ACCESSION NBR: 8201060307 DOC. DATE: 81/12/30 NOTARIZED: NO DOCKET #  
 FACIL: 50-244 Robert Emmet Ginna Nuclear Plant, Unit 1, Rochester G 05000244  
 AUTH. NAME AUTHOR AFFILIATION  
 MAIER, J.E. Rochester Gas & Electric Corp.  
 RECIPIENT NAME RECIPIENT AFFILIATION  
 CRUTCHFIELD, D. Operating Reactors Branch 5

SUBJECT: Forwards comments on NRC-810727 draft evaluation of SEP  
 Topic VI-4, "Containment Isolation Sys." Two oversize  
 drawings encl. Aperture cards are available in IPDR.

Subject: SEP Topic VI-4, Containment Isolation System  
R.E. Ginna Nuclear Power Plant  
Docket No. 50-244

PENETRATION NO. 102

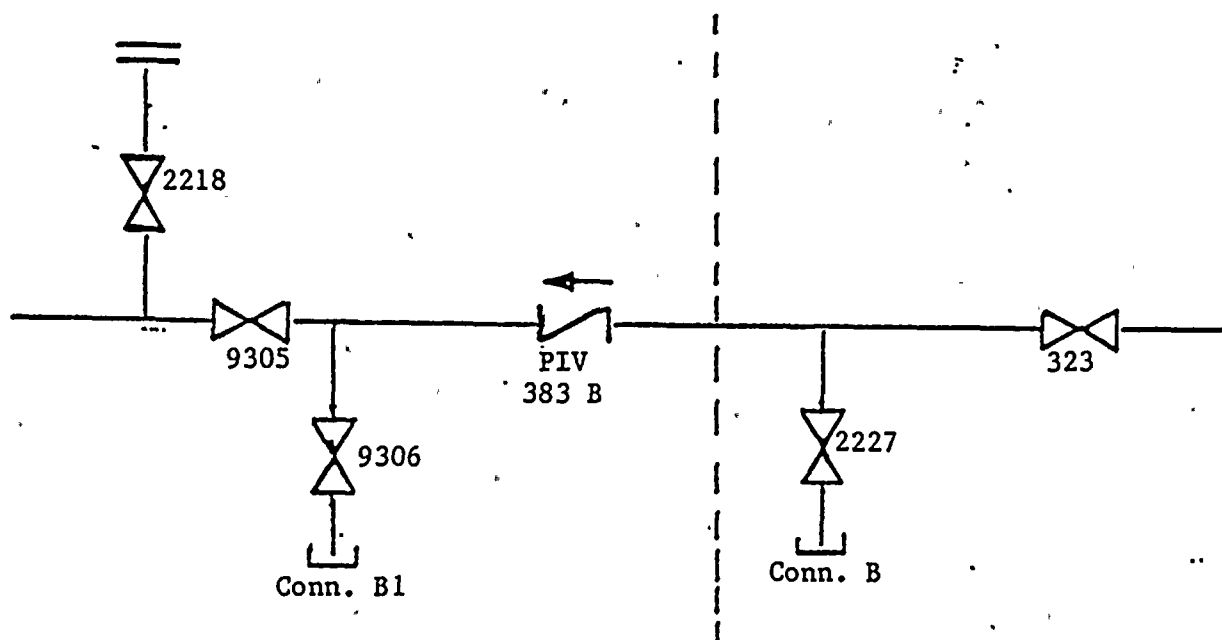
Penetration 102 (no NRC evaluation) (33013-433), the alternate charging line, is similar in function and arrangement to the charging line, penetration 100, which was judged acceptable by the NRC evaluation. Both of these lines have two check valves inside the containment separating the charging lines from the reactor coolant system. One check valve in each line is inside the missile barrier and one check valve is outside the missile barrier. Each line also has an Air Operated Valve (AOV) inside containment but outside the missile barrier so that LOCAs in the loop compartments will not effect these valves. The AOV in the charging line is normally open; the AOV in the alternate charging line is normally closed. Both fail closed on loss of instrument air which occurs with containment isolation. The closed charging system and positive displacement pumps provide another isolation barrier outside containment. Therefore this penetration has adequate containment isolation capability.

PENETRATION NO. 112

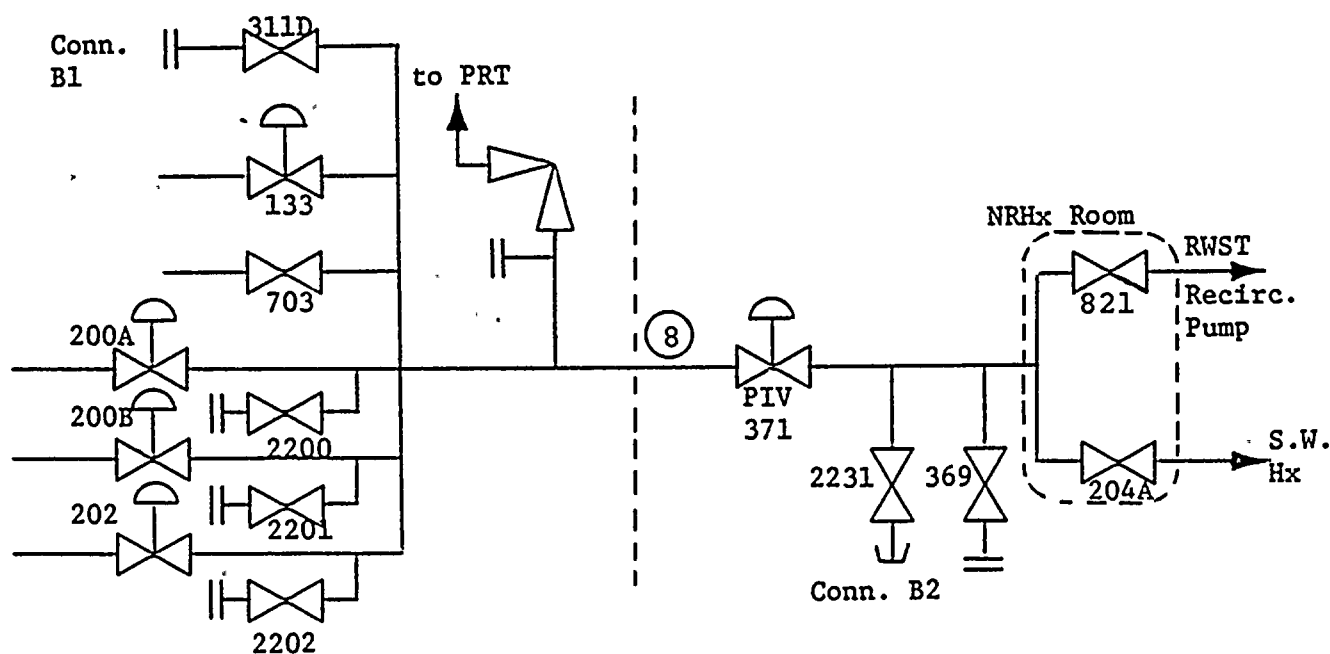
Penetration 112 (8) (33013-433), letdown to the non-regenerative heat exchanger, was judged in the draft evaluation report to meet the current GDCs. There is a difference between the as-built plant and the FSAR diagram. The orifice isolation valves (AOVs 200A, 200B and 202) do not receive containment isolation, or T, signals but do fail closed on loss of instrument air when the instrument air line is isolated. Further, AOV 427 upstream of the letdown orifices will be closed on low pressurizer level. This valve, however, is not outside the missile barrier and does not qualify as a containment isolation valve. It also fails open on loss of air. AOV 371 and the closed chemical and volume control system outside containment provide adequate containment isolation capability even without the additional protection from the letdown orifice isolation valves.

PENETRATION NO. 121

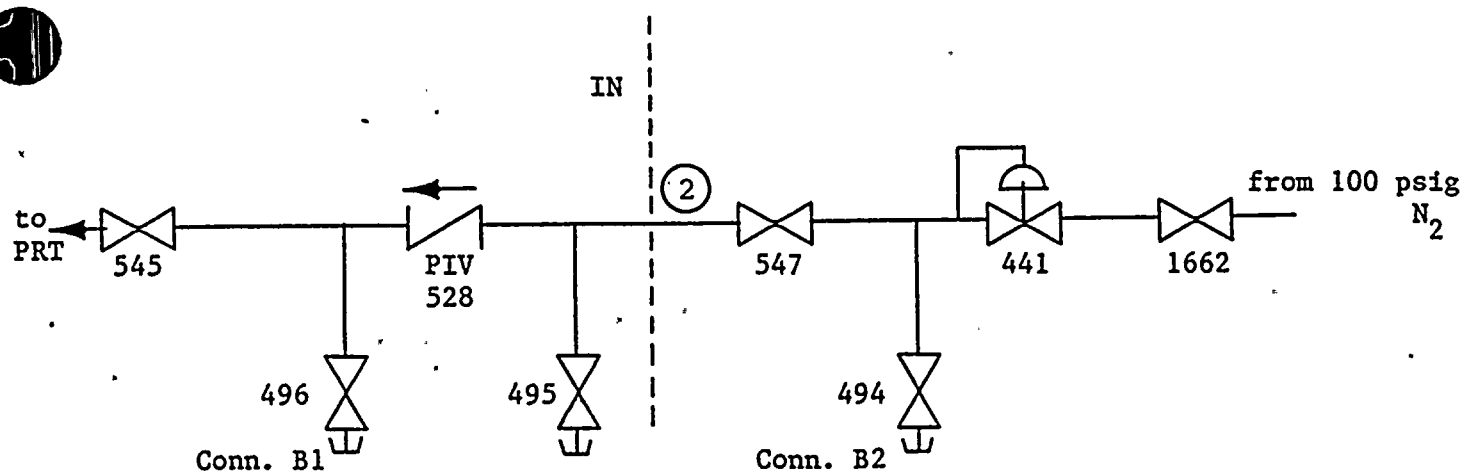
Penetration 121 (2) (33013-424), nitrogen supply to pressurizer relief tank (PRT), is protected by check valve 528 inside containment and pressure control valve (PCV) 441 outside containment. PCV 441 maintains the downstream pressure at a constant 0.5 psig. If the PRT is ruptured and CV 528 fails and containment pressure is elevated above 0.5 psig, PCV 441 will be closed. Pressure outside the containment upstream of PCV 441 will be 100 psig toward the containment preventing leakage. If the PRT is ruptured, CV 528 fails, and containment pressure is less than 0.5 psig PCV 441 may open in an attempt to raise the downstream piping pressure but 100 psig nitrogen flow toward the containment will prevent leakage. Manual valve 547 near the containment wall can be used in the long term to isolate the nitrogen supply line. Therefore, the isolation provisions for this penetration are acceptable in the current configuration.

PENETRATION NO. 121

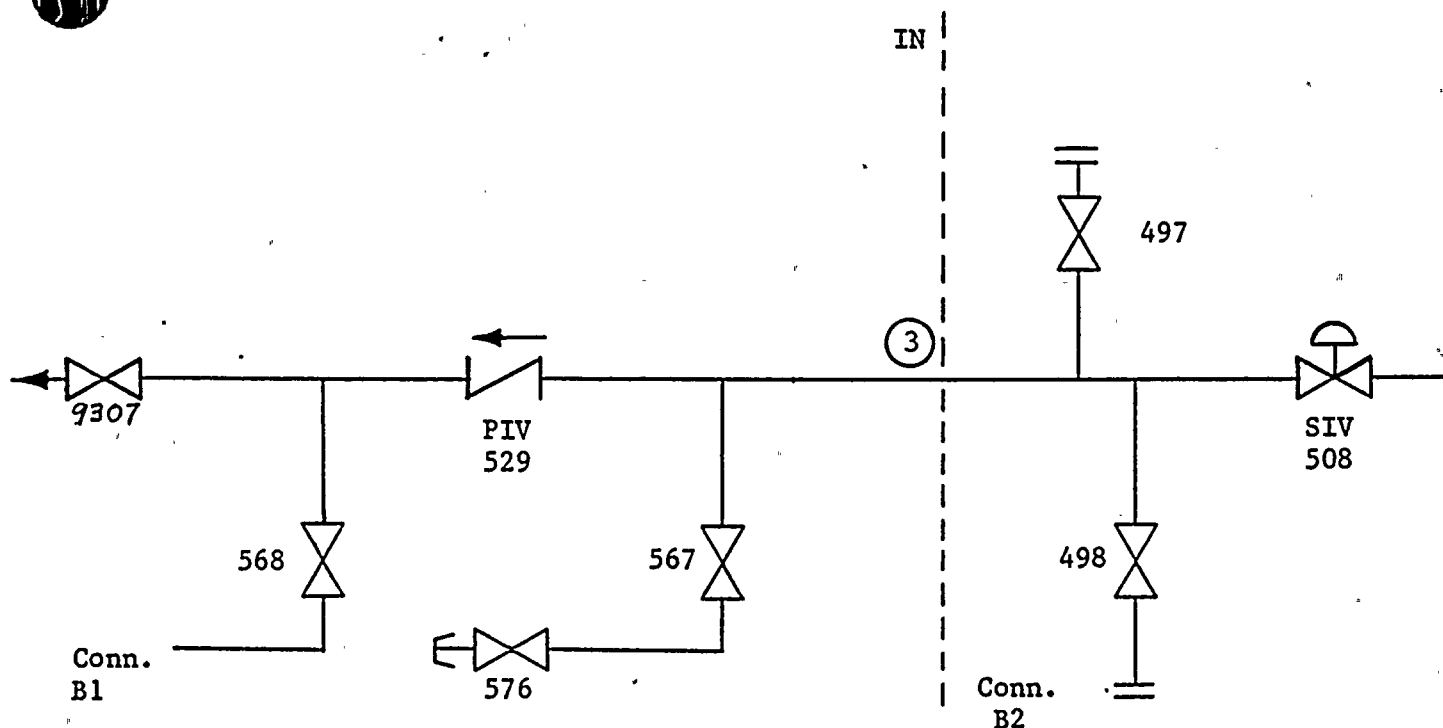
Penetration 121 (3) (33013-424), reactor makeup water to PRT, is protected by check valve 529 inside containment and AOV 508 outside containment. The draft evaluation report noted only one apparent difference from current criteria; AOV 508 should close automatically. This valve does close automatically upon receipt of a containment isolation signal. Therefore, this penetration is judged acceptable as presently configured.

PENETRATION NO. 123 (BOTTOM)

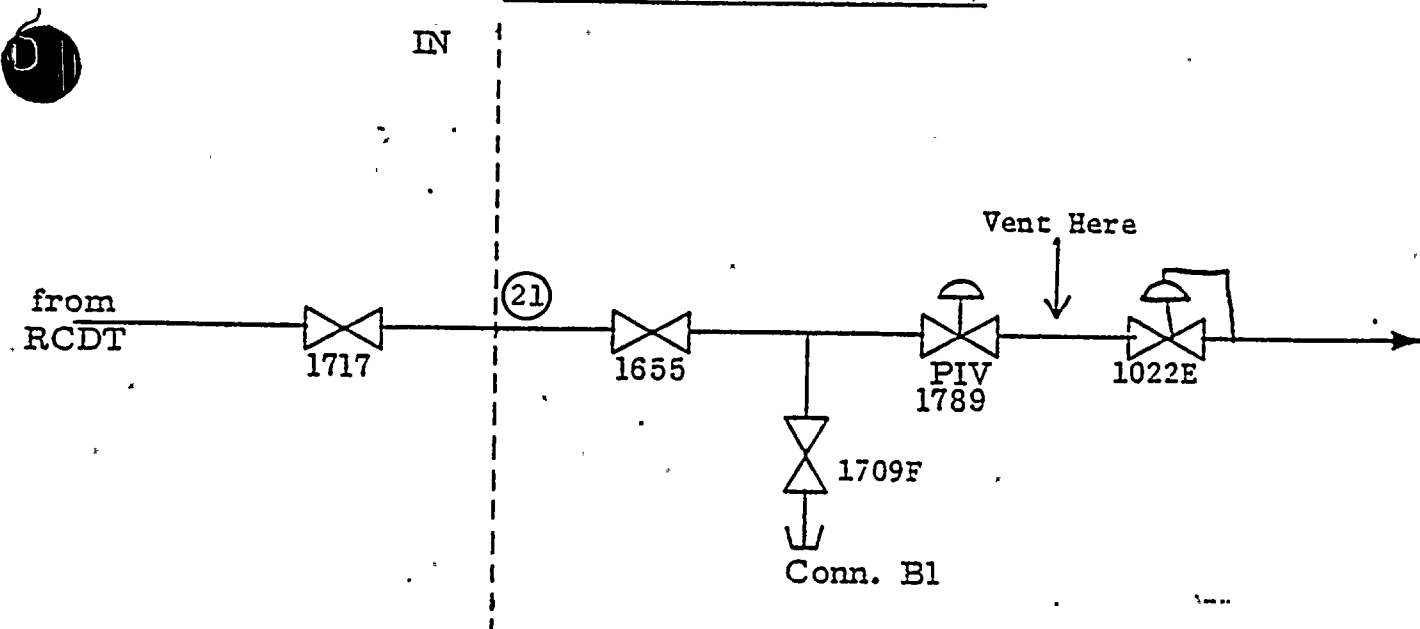
Penetration 123 (21) (33013-431), Reactor Coolant Drain Tank (RCDT) to the gas analyzer, is 3/8 inch tubing and is similar to penetration 120, PRT to the gas analyzer. AOV 1789, receives an isolation signal and is less than 2 feet from the wall. MV 1655 is less than a foot from the wall and will provide redundant isolation capability should it be required. MV 1655 is also periodically checked for leakage. The need for additional isolation capability will be evaluated during the integrated assessment.

CONTAINMENT POST ACCIDENT AIR SAMPLE (AUX. BLDG.)  
PENETRATION NO. 124

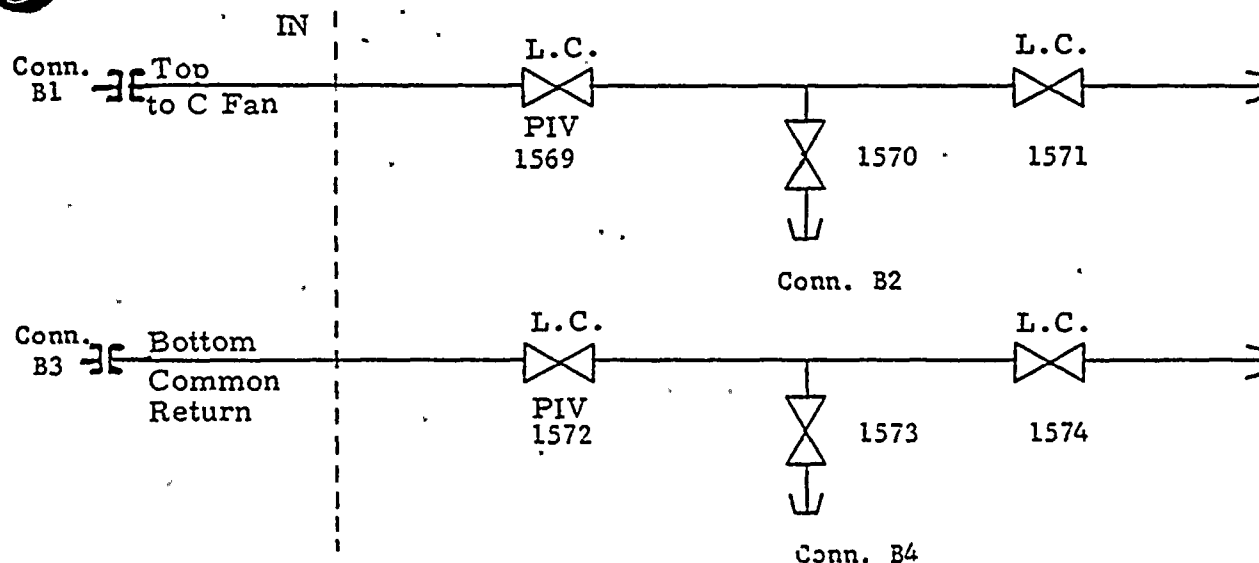
Penetrations 124, 203 and 305 (no NRC evaluation), containment post accident air sample lines, are small tubing penetrations which are closed during normal operation by at least 2 boundaries. Each line has two manual valves located close to the containment wall. In addition, each line is fitted with a tubing cap. These lines are closed and would be opened only to take a sample following an accident and then reclosed. This valve arrangement and operating mode meets the intent of Safety Guide 11, Instrument Lines Penetrating Primary Reactor Containment. Therefore, these penetrations should be found acceptable in the current configuration.

PENETRATION NO. 125

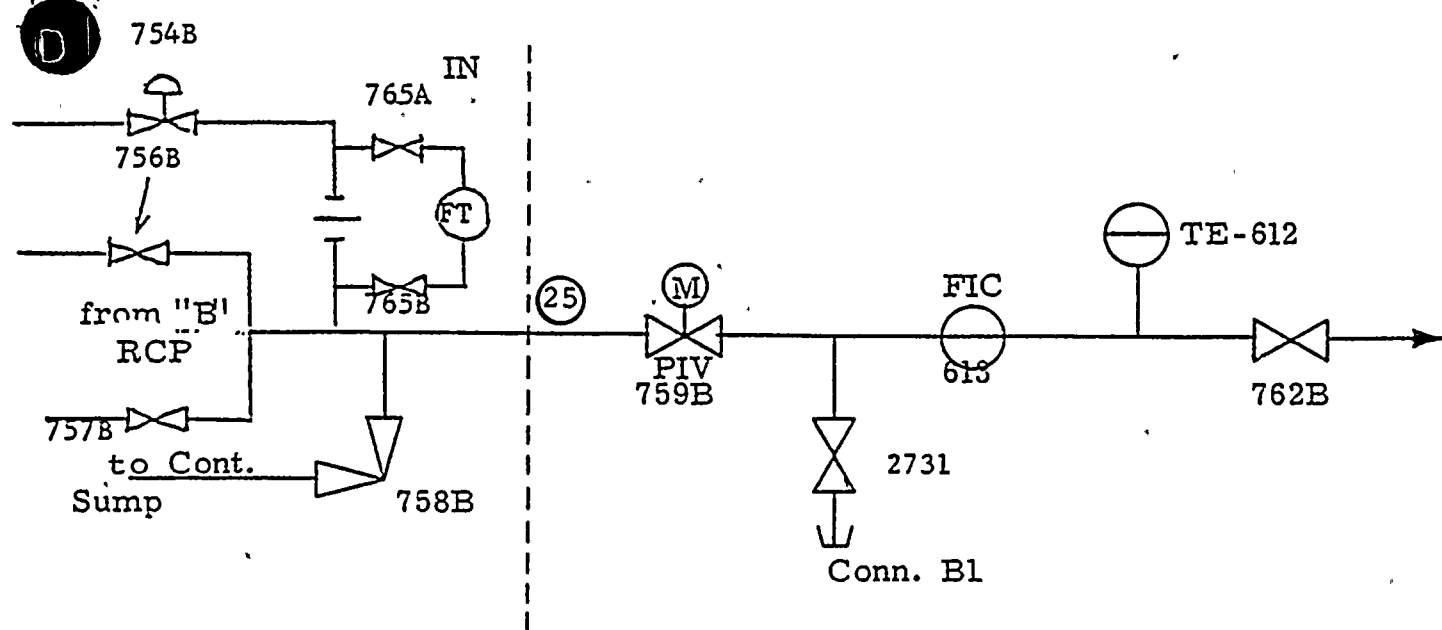
Penetrations 125 and 126 (25) (33013-435), component cooling water from the reactor coolant pumps, are protected by remote manual isolation valves MOV 759A and MOV 759B and by the closed auxiliary coolant system outside containment. It is desirable to maintain flow through these lines to facilitate operability of the reactor coolant pumps. Component cooling water cools the reactor coolant pump thermal barrier and protects the number one seal in the event the reactor coolant pumps are operating. The lines are not part of the reactor coolant pressure boundary and are not connected directly to the containment atmosphere. This system arrangement meets the requirements of GDC 57, the applicable design criterion. In addition, the closed system outside containment (operated at a normal pressure greater than containment accident pressure) provides further leak protection.

PENETRATION NO. 127

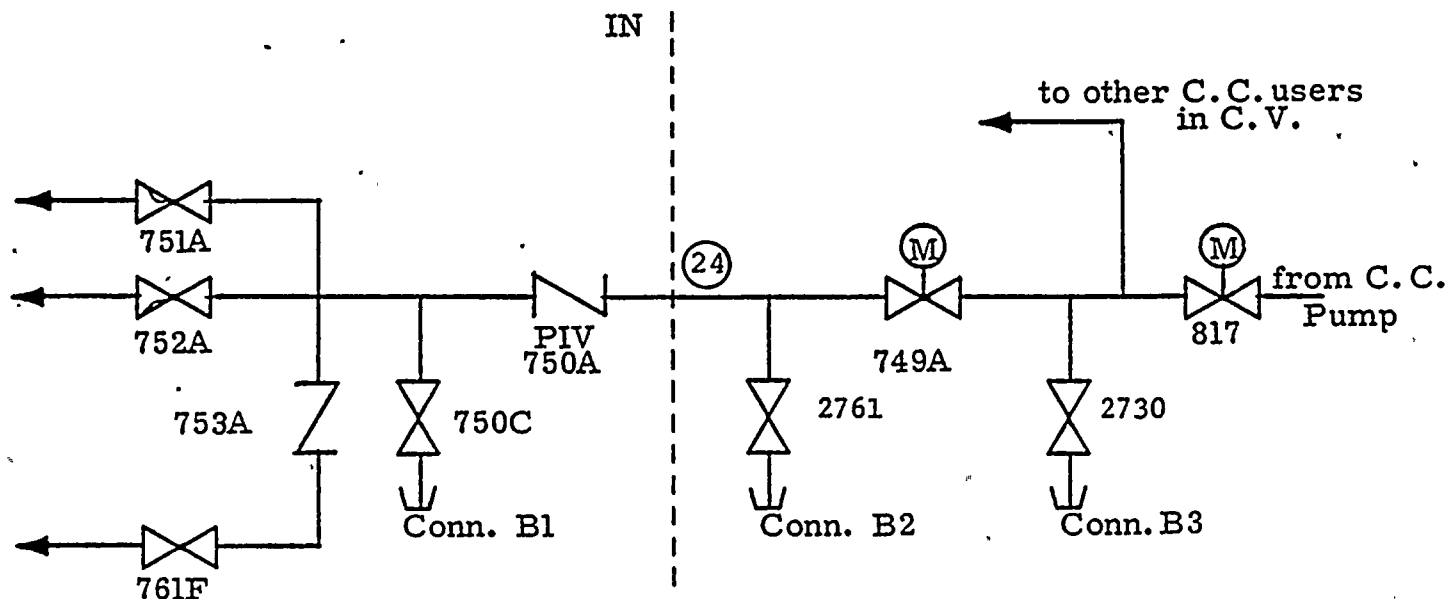
Penetrations 127 and 128 (24) (33013-435), component cooling water to RCP 1A and RCP 1B, are protected by check valves 750A and 750B inside containment and MOVs 749A and 749B outside containment. The applicable GDC for these lines which are not part of the reactor coolant pressure boundary nor connected directly to the containment atmosphere, is GDC 57. Only the remote manually operated MOVs 749A and 749B are required. In addition, the check valves inside containment and the closed system outside containment (operated at a normal pressure greater than containment accident pressure) provide further leakage protection. Therefore, the isolation capability which has been provided for this penetration exceeds that required by current criteria and the configuration should be found acceptable.

# REACTOR SUPPORT COOLING ( IN & OUT ) PENETRATIONS, NO. 130 & NO. 131:

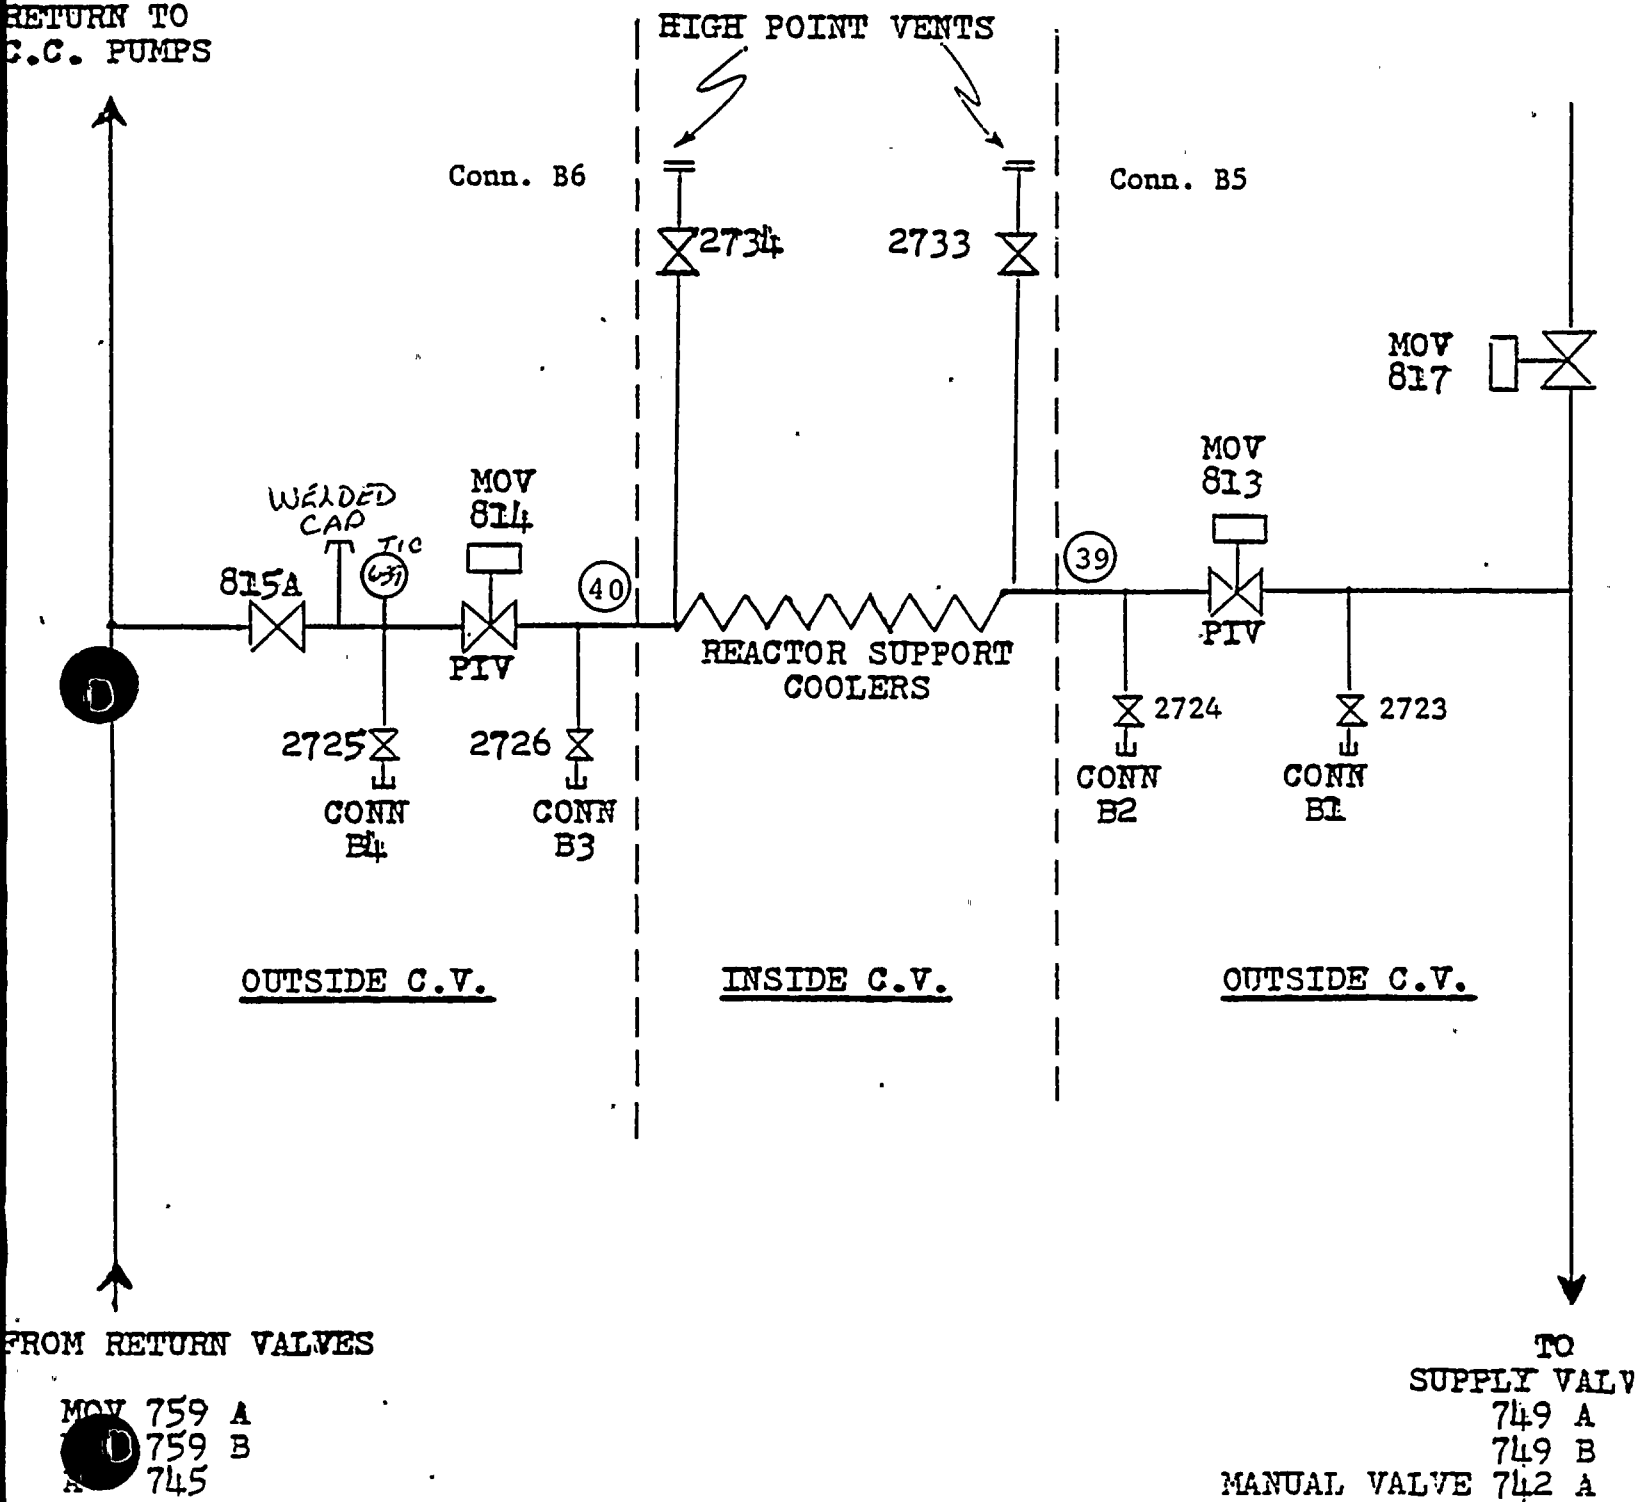
Penetrations 130 and 131 (39 and 40) (33013-435), reactor support cooling lines in and out, are each provided with a single valve, MOV 813 and MOV 814, outside containment which receives a containment isolation signal. The reactor support cooler system is a closed passive system inside containment and the component cooling water system is a closed system outside containment. The CCW system operates at a pressure higher than containment accident pressure. Thus, the closed CCW system and the automatic isolation valves provide redundant protection against leakage and meet the requirements of GDC 57, the applicable design criterion.
